ADDENDUM #2

Reference: Bridgerland Applied Technology Campus – Boiler Replacement and Control Upgrade
DFCM Project No. 06011210

Subject: **Addendum No. 2**

MH-101-R2-1

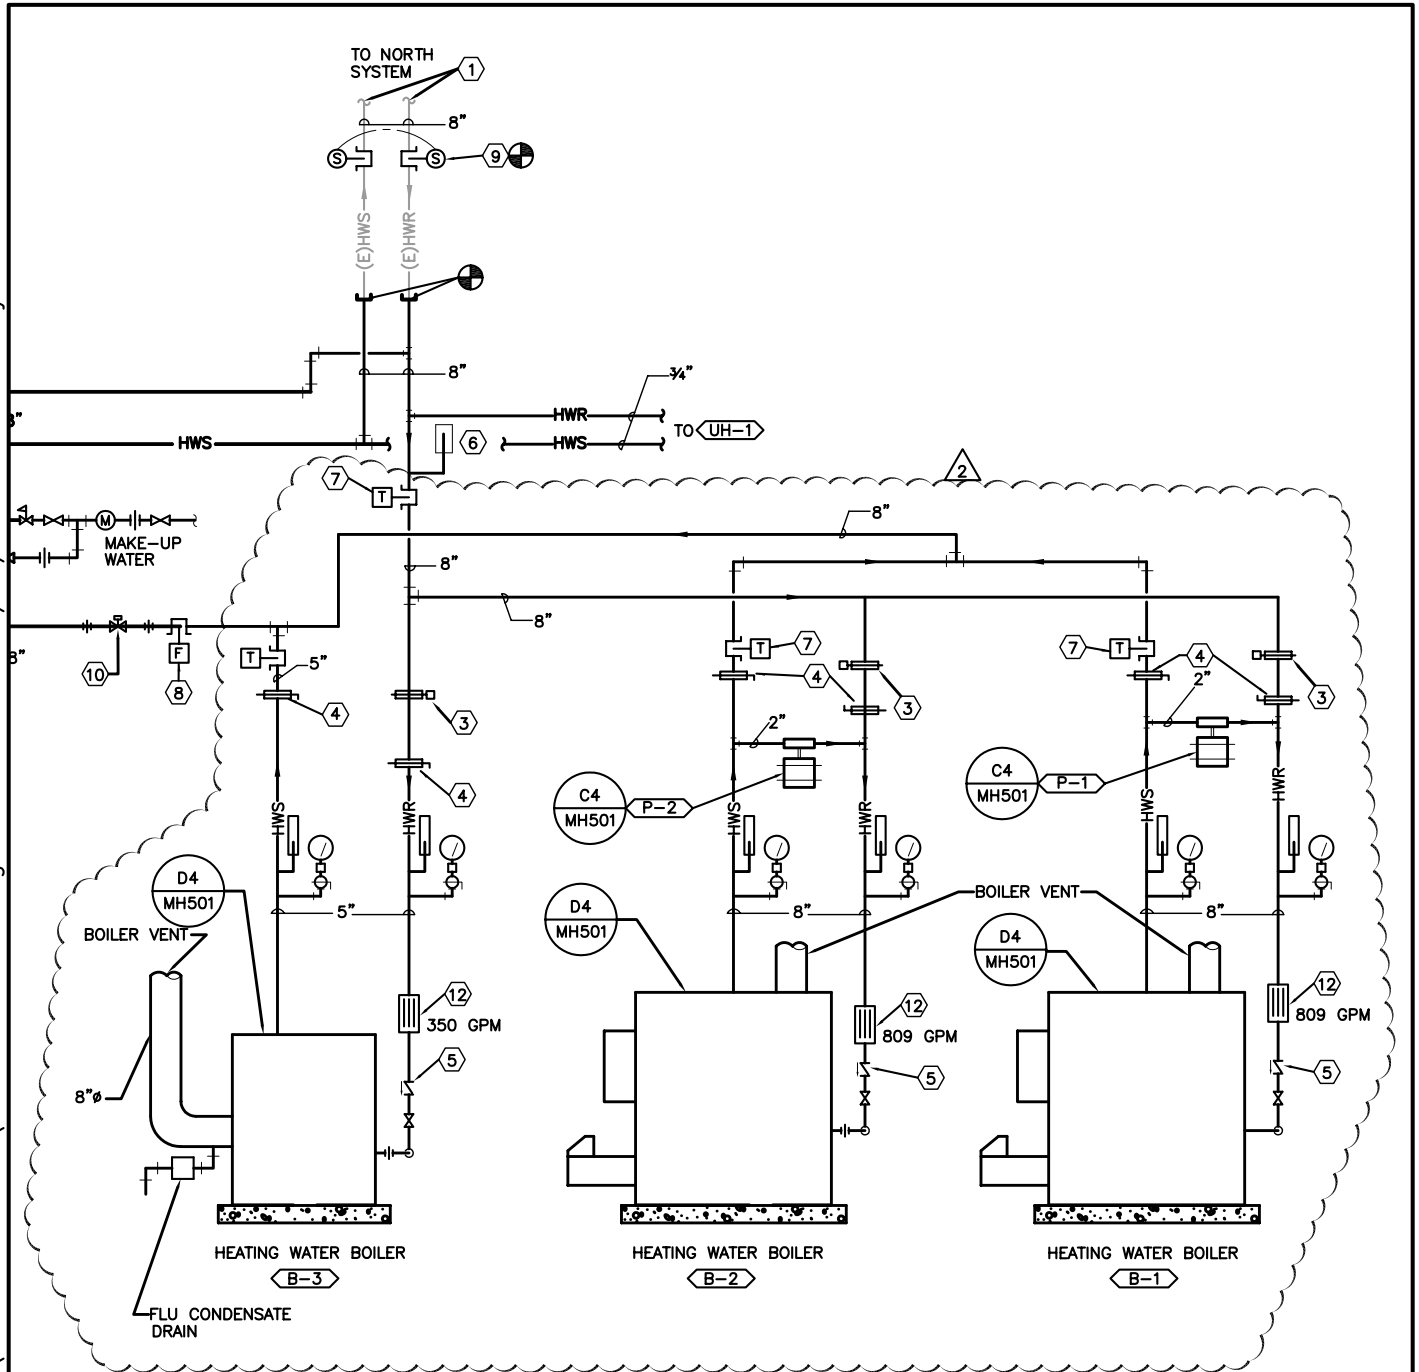
1. Change routing of HWS piping to reduce length of piping. Add shut-off isolation valve to 8" HWS. Change 5" See attached.

MH-601-R2-1

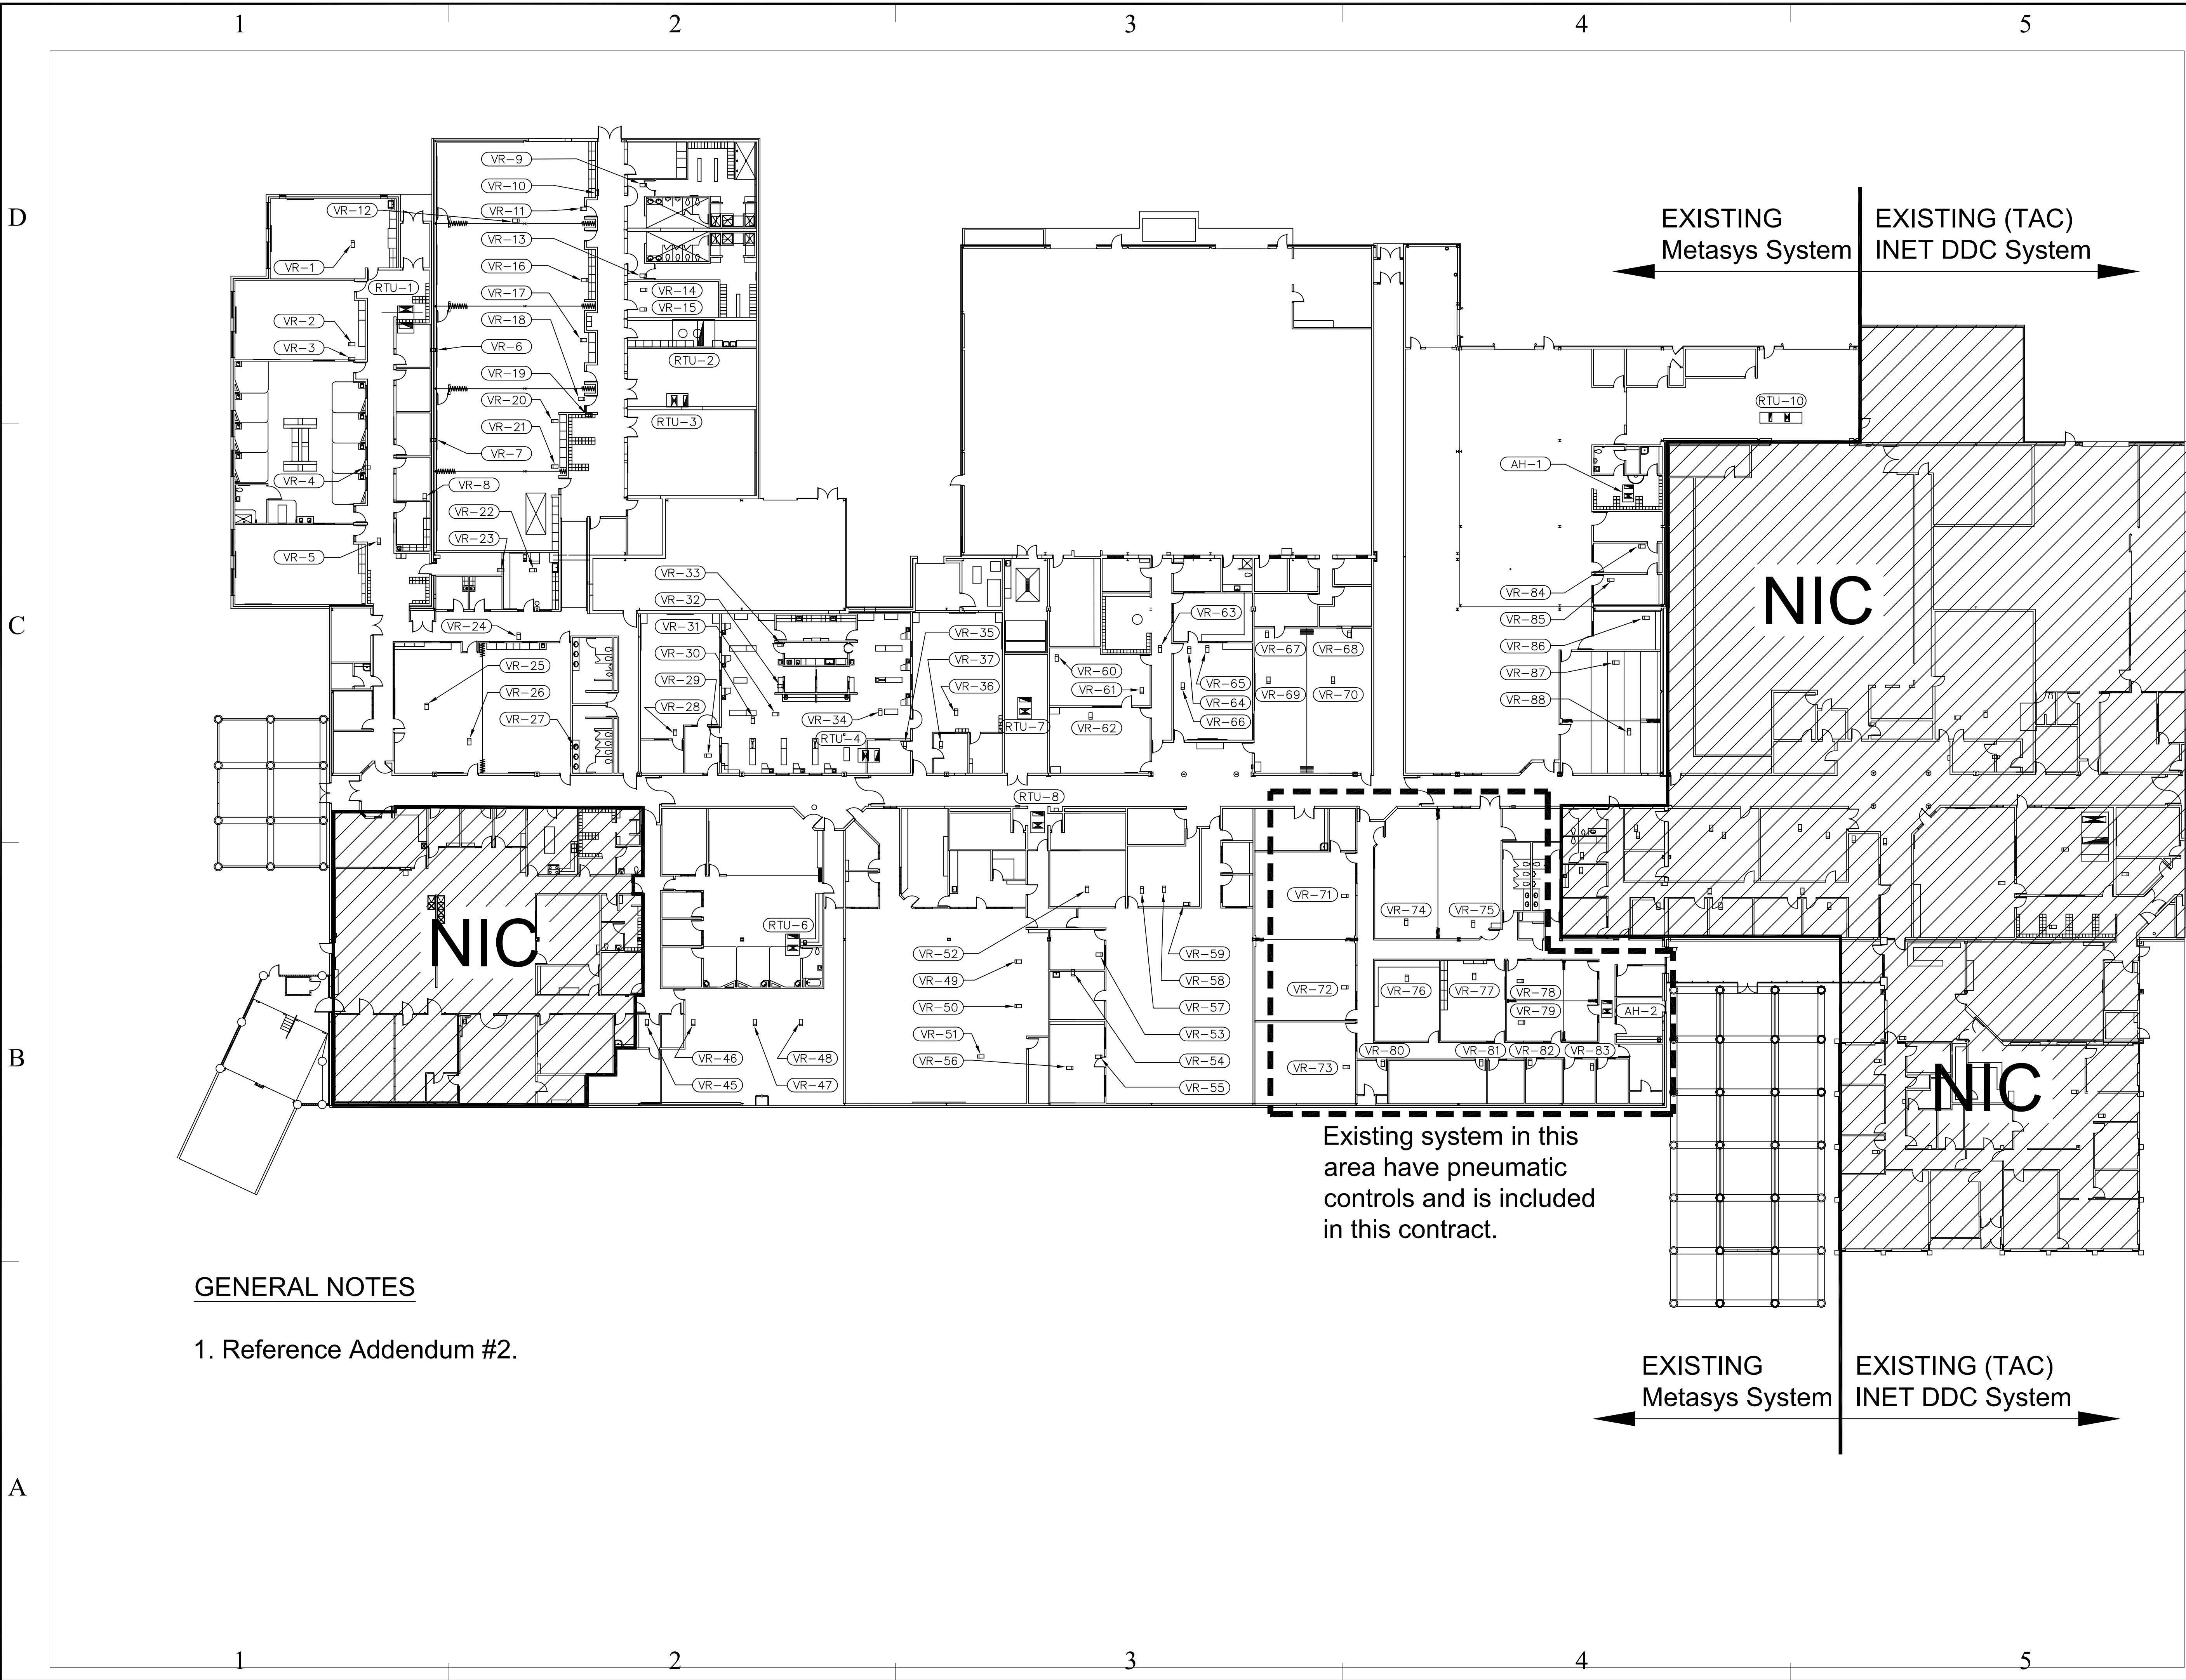
1. Change boiler schematic to match new piping layout as mentioned above. See attached.
